From: David H. Brown [DHBrown@gvea.com]
Sent: Thursday, September 05, 2013 5:42 PM
To: Hammond, Michelle
Cc: David H. Brown
Subject: FW: REQUEST FOR ADDITIONAL INFORMATION
Attachments: HEALY-NUREG 1556 V4 APP_D 7-11.pdf; unit 1 Kay-Ray_Sensall SSD INSTALL SURVEY 28JAN1993001.pdf; GENERAL LICENSEE REPORT.pdf

License No.: 50-29058-01
Docket No.: 030-33010
Control No.: 580239

This is in reference to your renewal application dated March 20, 2013 regarding Nuclear Regulatory Commission License No. 50-29058-01. In order to continue our review, we need the following additional information:

Kay-Ray/Sensall No. 7838-041

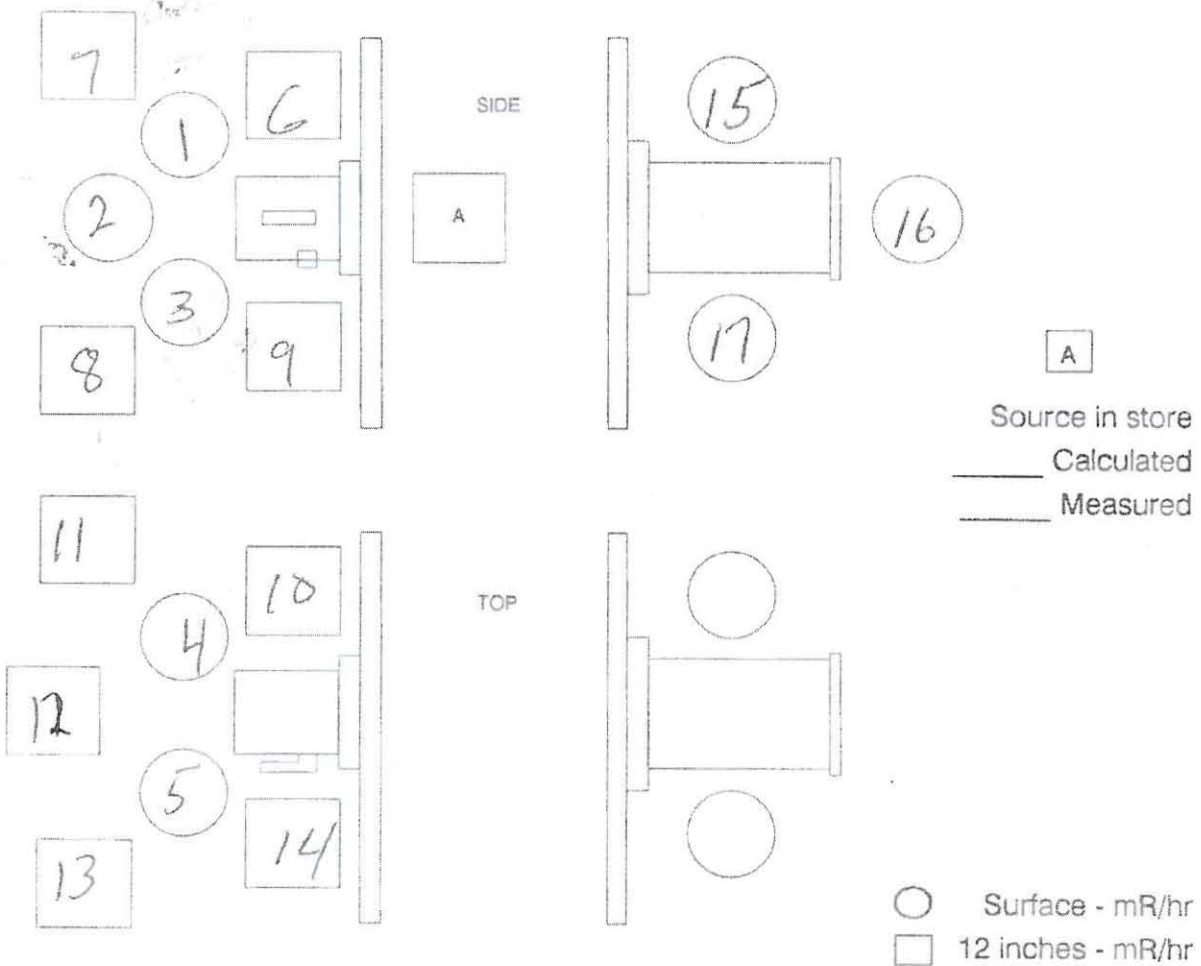
- 3) Indicate how you will ensure compliance with 10 CFR 20.1501, O&E procedures, and shutter checks **WITHOUT** having a survey instrument.
The survey results from the installation of these SSD's is attached in file "unit 1 Kay-Ray Sensall SSD INSTALL SURVEY 28 Jan1993". It shows exposure limits are lower than what would require personnel monitoring devices. I will also contact the manufacturer of the device to get a prospective evaluation of the device for routine activities such as the shutter check.
